Product Change Notice (PCN)

PCN Number: **PCN-0450879R-01**

Product(s) Affected: **PJ1-021**

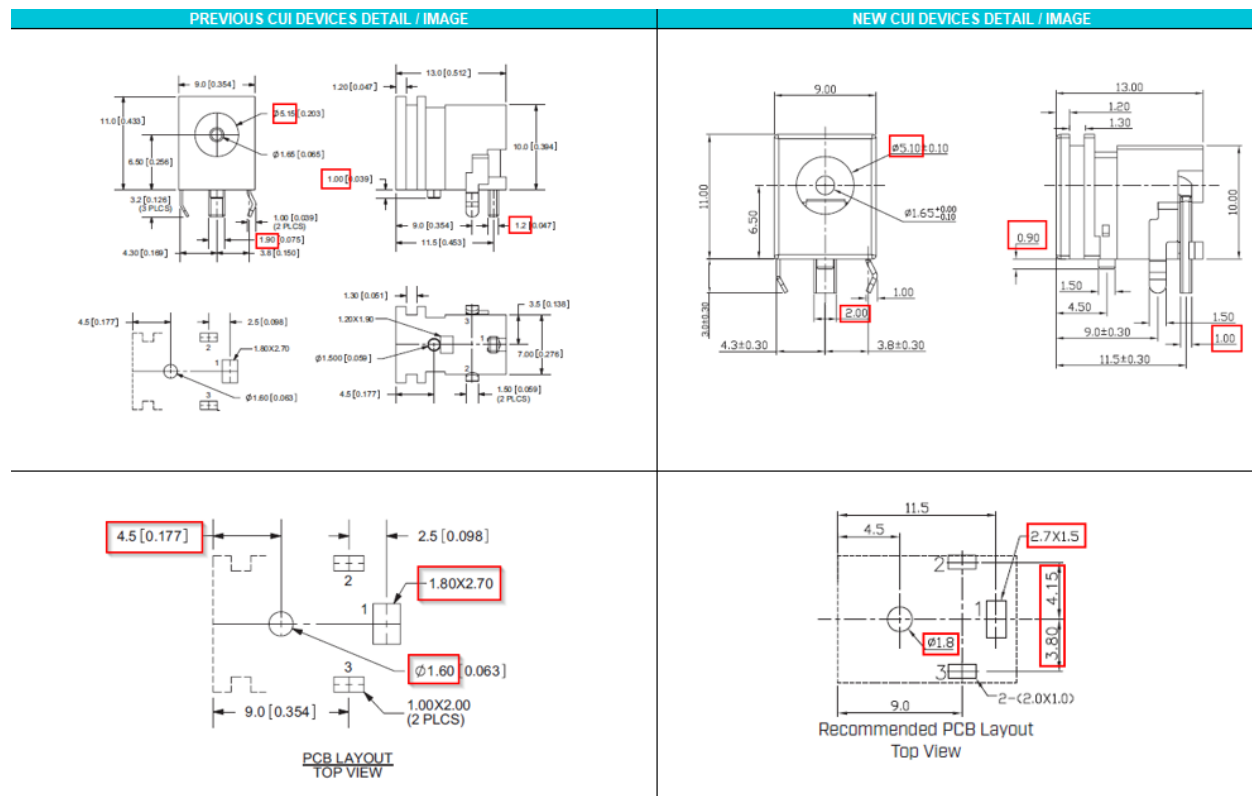
Description of Change: **Minor Housing and footprint differences. Material Change on the housing and terminals. See image Below**

PREVIOUS CUI DEVICES DETAIL / IMAGE			NEW CUI DEVICES DETAIL / IMAGE		
	MATERIAL	PLATING			
center pin	copper	silver	DESCRIPTION	MATERIAL	PLATING/COLOR
terminal 1	copper	silver	center pin	brass	nickel
terminal 2	copper alloy	silver	terminal 1	brass	nickel
terminal 3	brass	silver	terminal 2	bronze t=0.30	silver
plastic	PBT		terminal 3	brass t=0.40	silver
			housing	PBT (UL94V-0)	black

MATING PLUG
Jack Insertion Depth: 8.5 mm

MATING PLUG
Jack Insertion Depth: 8.7 mm
